PLANT NAME: Turkey Pt 3 & 4

Re: Turkey Point Units 3 and 4  
Docket Nos. 50-250 and 50-251  
Overpressurization Issue

TURKEY POINT UNITS 3 and 4  
DOCKET NOS. 50-250 and 50-251  
OVERPRESSURIZATION ISSUE

Turkey Point Units 3 and 4  
Docket Nos. 50-250 and 50-251  
Overpressurization Issue

FIGURE 1

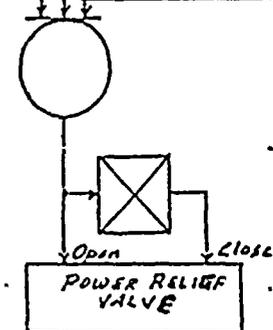
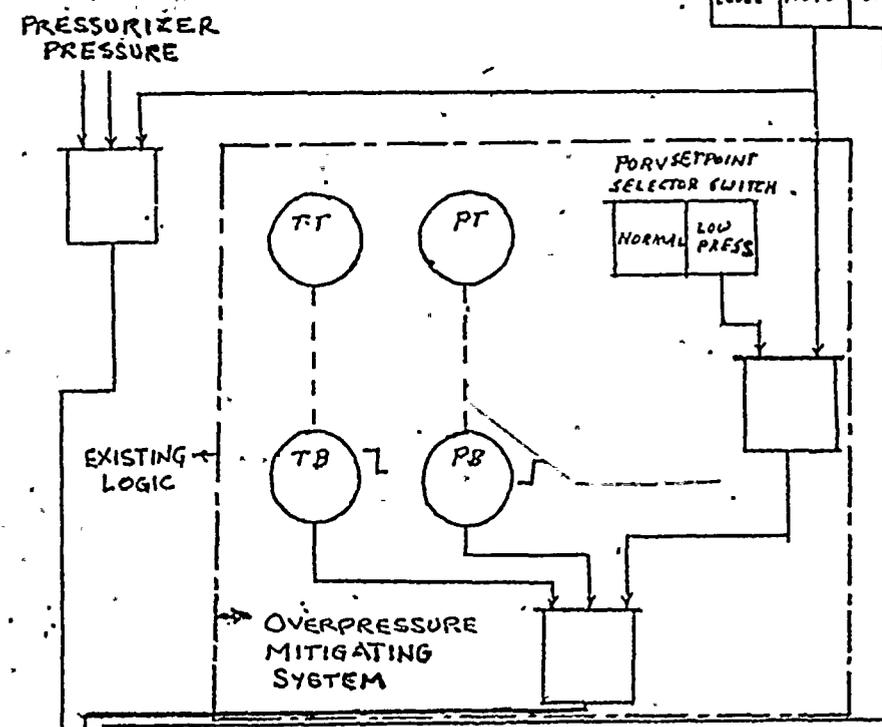
The power operated relief valves, equipped with a low setpoint feature, will be used as the pressure relieving mechanism. The low setpoint feature is energized and de-energized by the operator by use of an administratively controlled key-lock switch in the control room. The pressure signal for the Overpressure Mitigating System will be obtained from redundant wide range pressure transmitters - the same transmitters that control the RHR suction valve interlocks. An interlock with reactor coolant temperature is included to reduce the probability of inadvertent actuation. Temperature indication for the interlock is obtained from the RCS wide range temperature instrumentation. Figure 1 presents a functional representation of the proposed system. The proposed low pressure feature parallels and does not override the existing actuation logic.

The power operated relief valves are spring loaded closed and require air to open. The air is presently supplied by a control air source. A redundant supply of air to the valves will be provided through the existing SIS accumulator nitrogen supply and pressure regulator with redundant check valves to ensure that backfeeding the air supply does not occur.

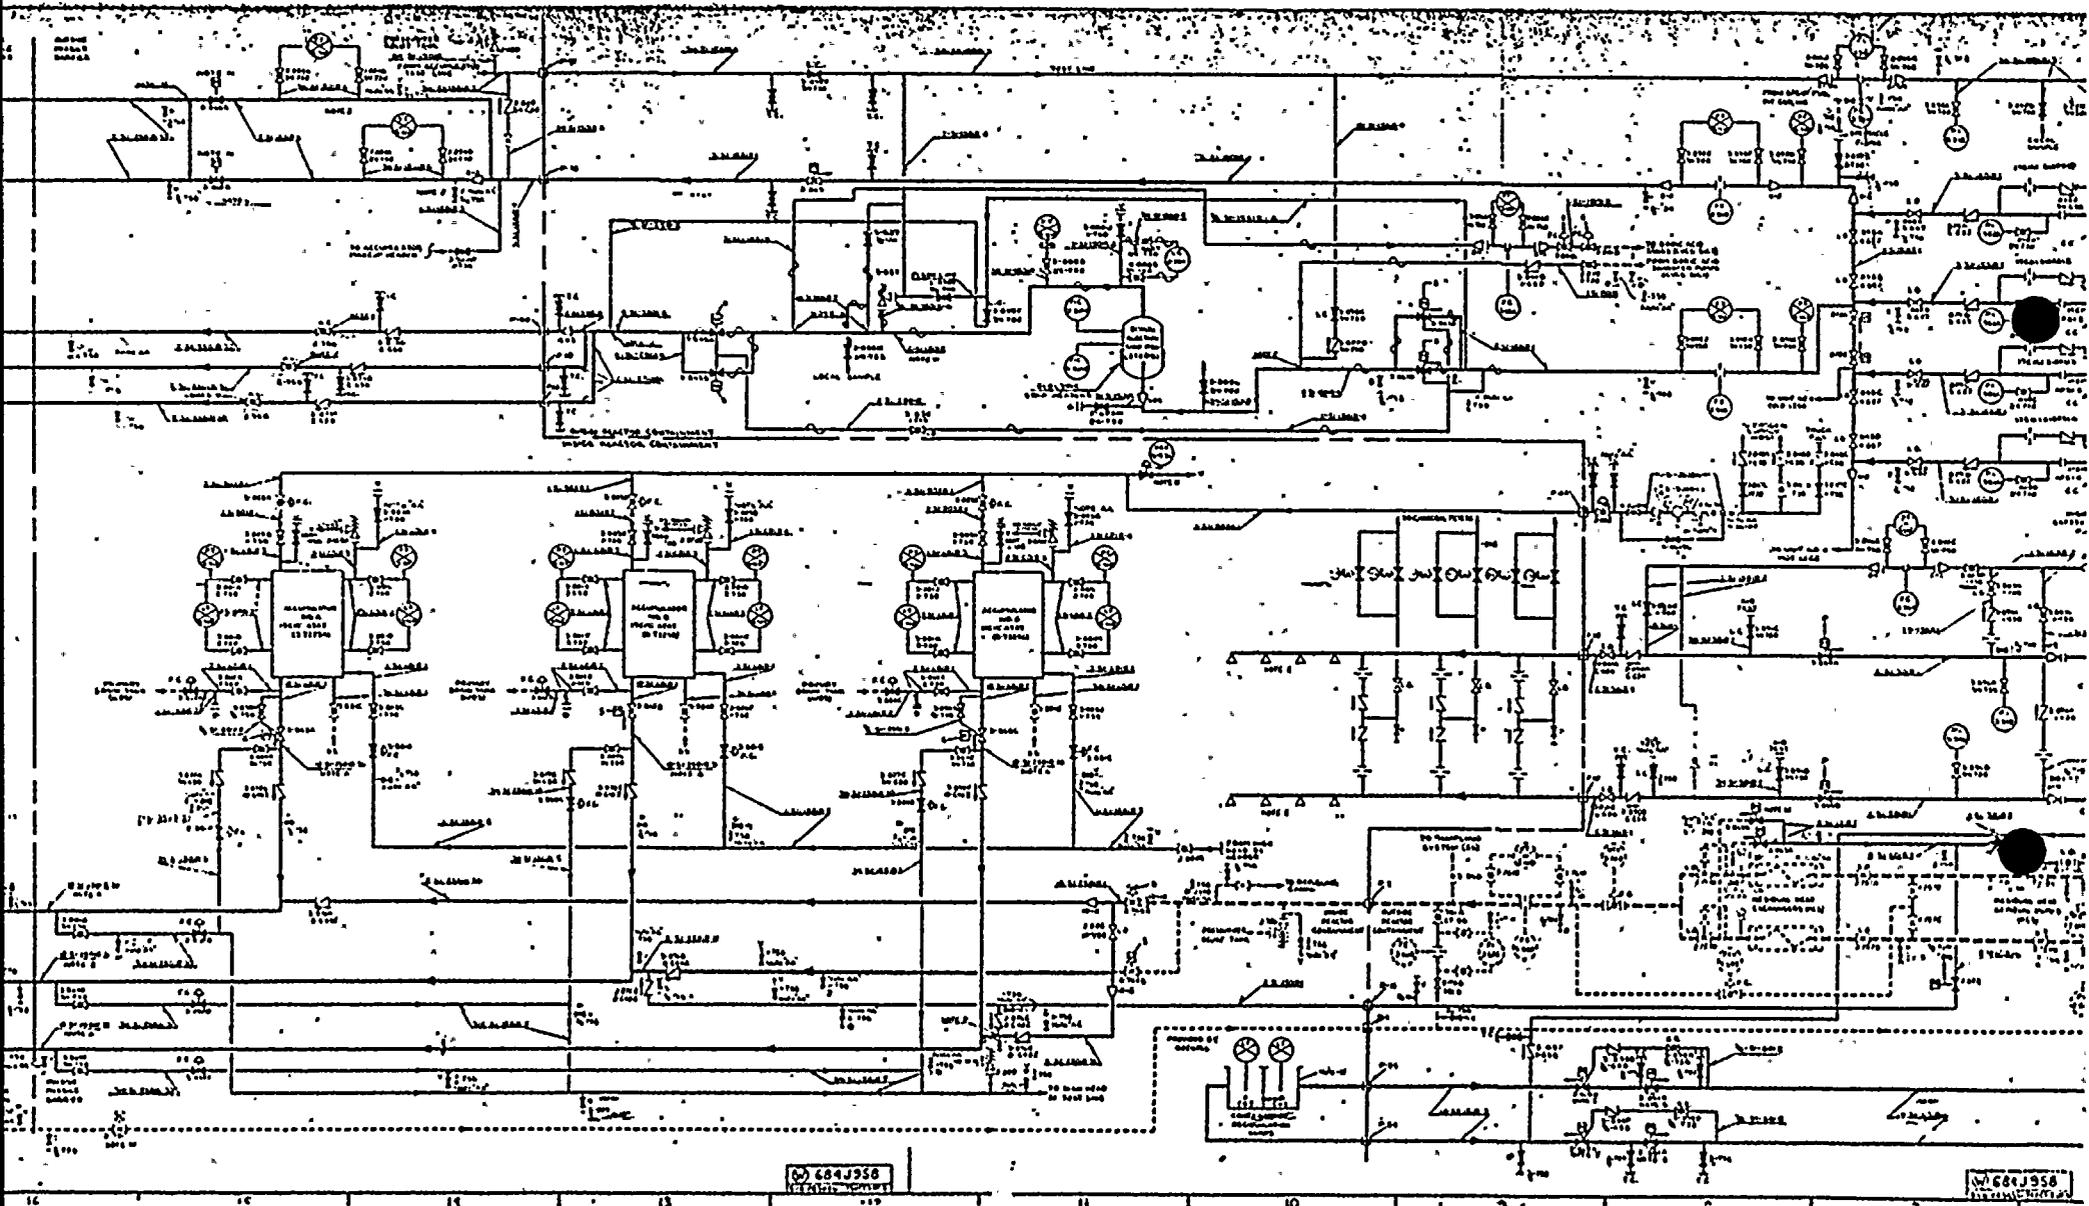
- b. See 2.d above.
- c. There are no temperature limits associated with starting the RCP's in a water solid condition.
- d. See FSAR Figure 4.2-1 for location of RCS temperature elements.
- e. Prior to securing the RCP's, the RCS is brought to an isothermal condition by cooling down the RCS, removing the steam generators from service, collapsing the bubble, and cooling down the pressurizer.
- f. In general, only one RCP is started at a time, and it is allowed to come to rated speed before the second pump is started. During the fill and vent and heat up procedure, the RCP's are started sequentially and in a controlled fashion so that thermal transients and pressure spikes will not produce an overpressure condition.
